**CITY OF PORTLAND, MAINE
DEVELOPMENT REVIEW APPLICATION
PLANNING DEPARTMENT PROCESSING FORM
DRC Copy**

35 Providence

RE: Application for – 35 Providence Street
(ID# 2003-0232, CBL#169-A-035)

PLAN SHOWING A STANDARD BOUNDARY SURVEY MADE FOR MARK PLOURDE
 PORTLAND, MAINE

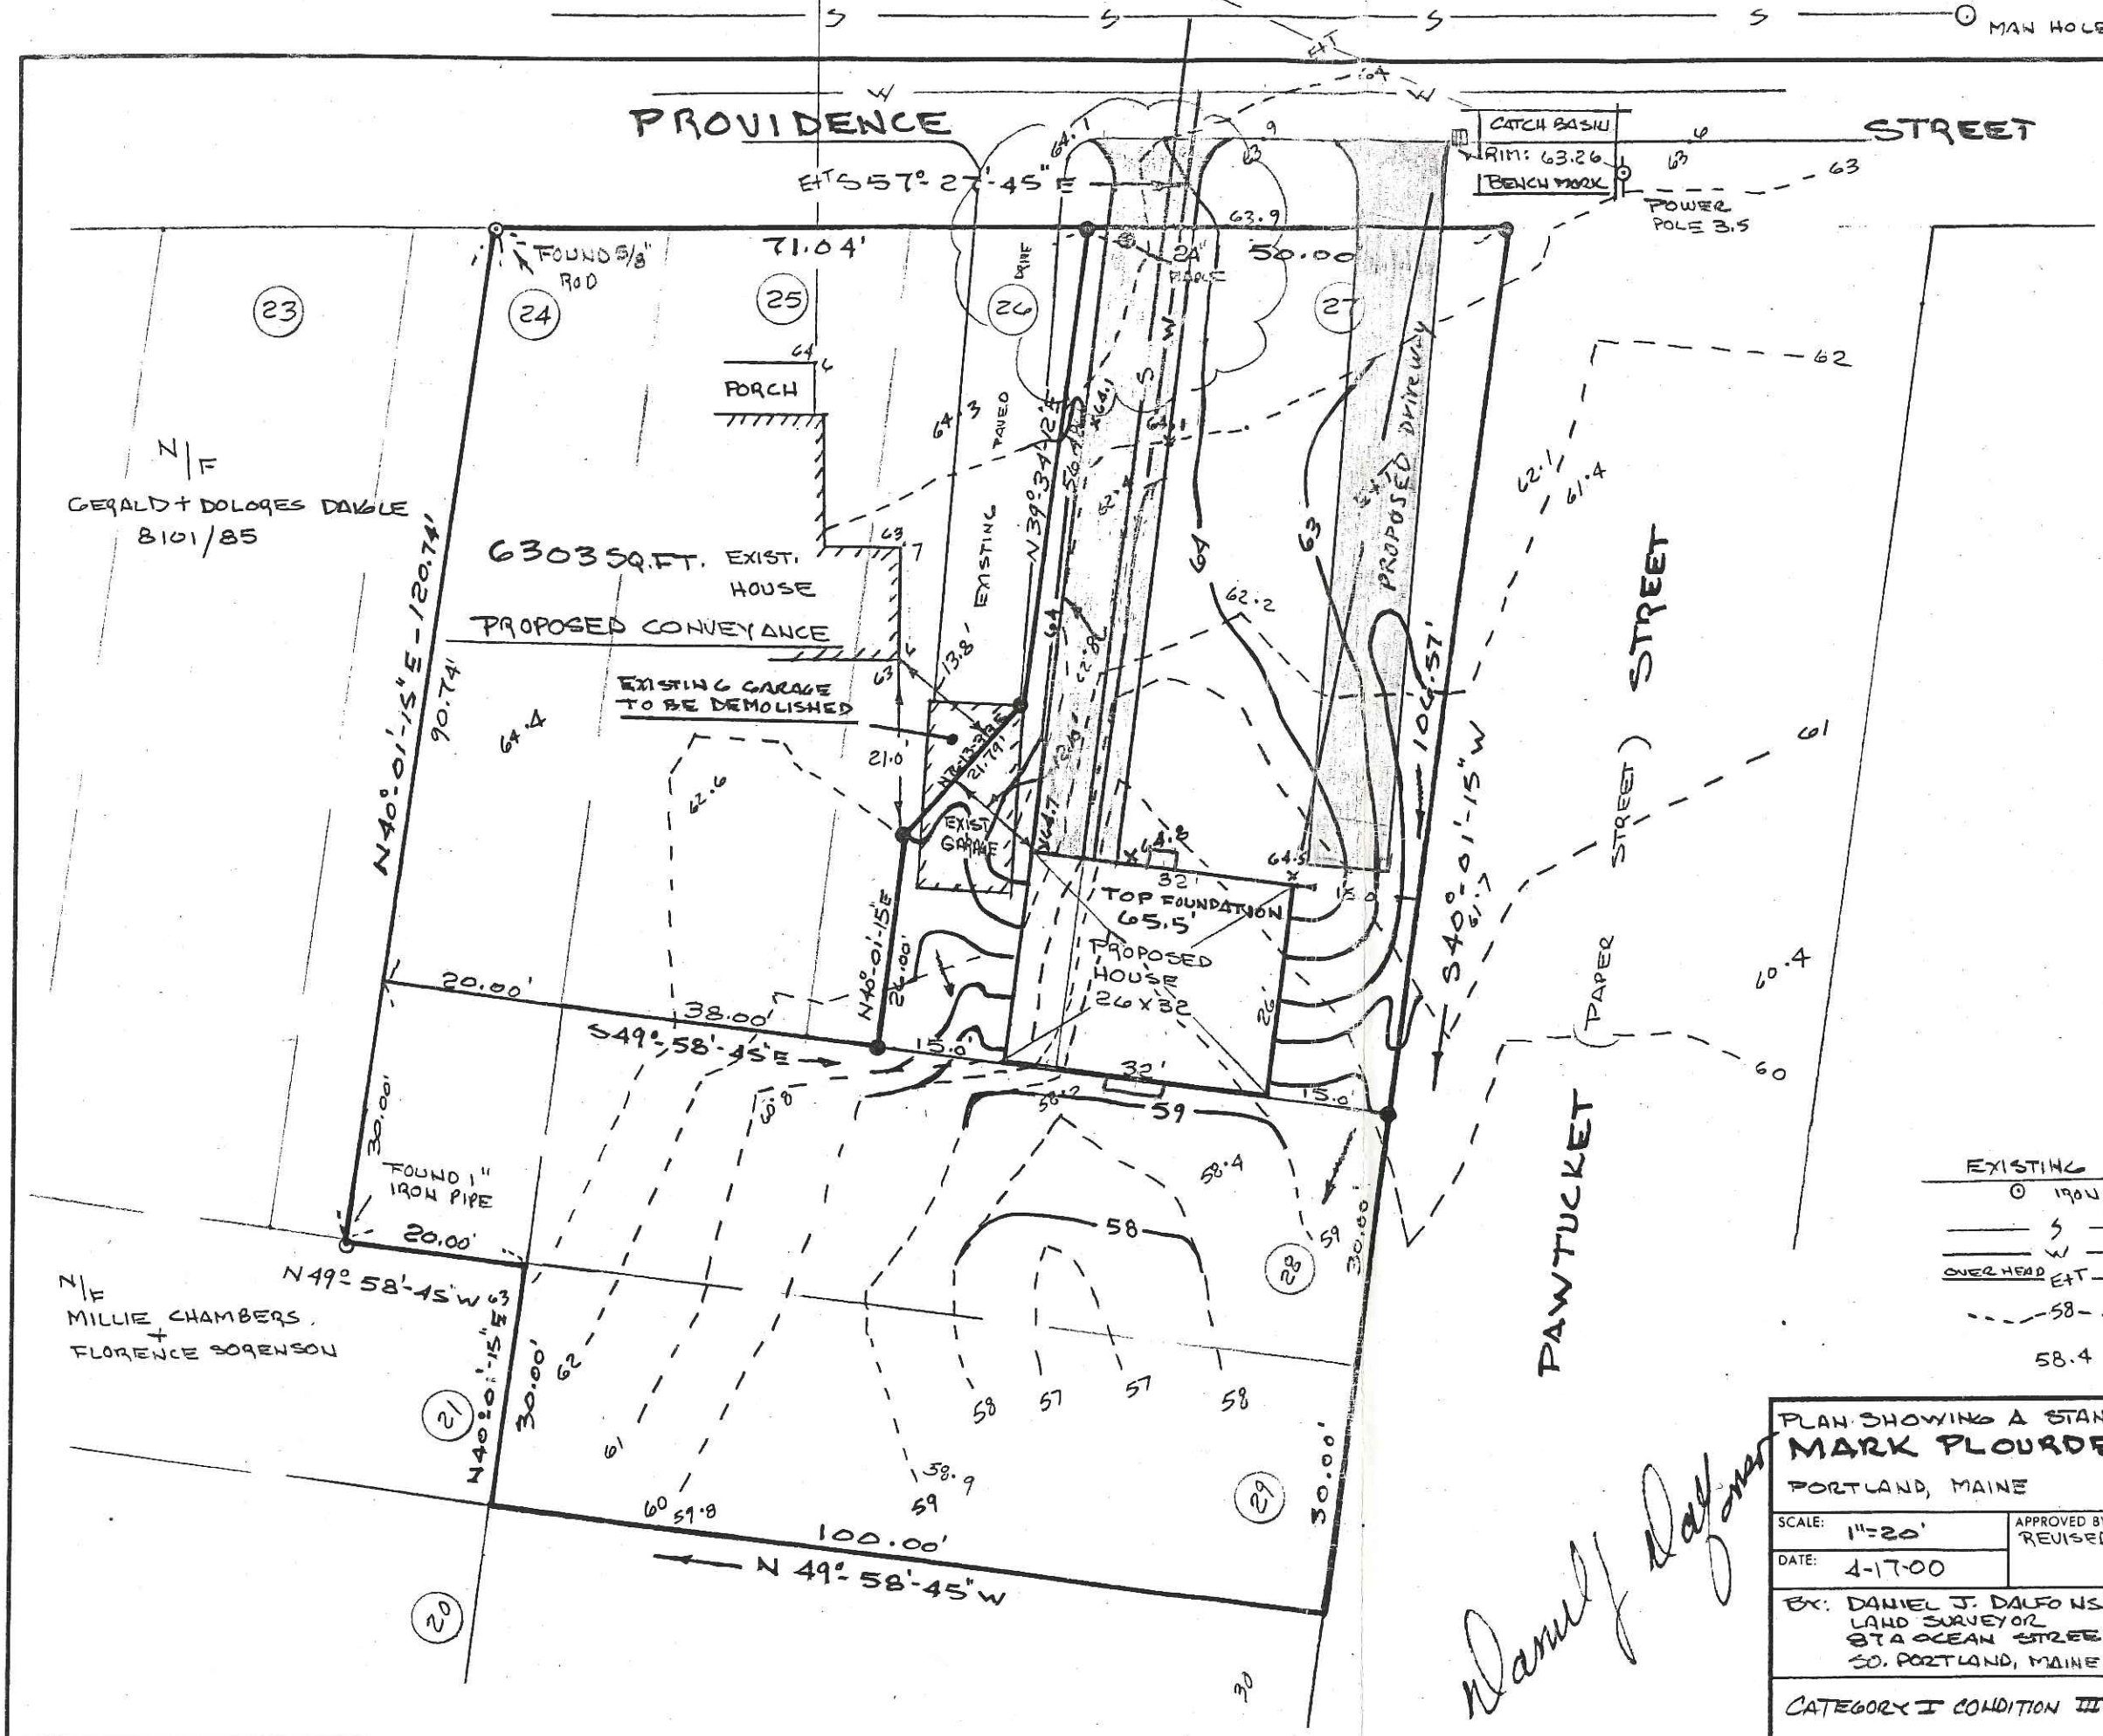
1. Please add a cleanout to the sanitary sewer lead. *Cleanout*
2. Please add two street trees to your site plan, as required for single family development. *Good*
3. The site plan appears to show two driveways/curb cuts. Is this correct? *One Curb Cut*
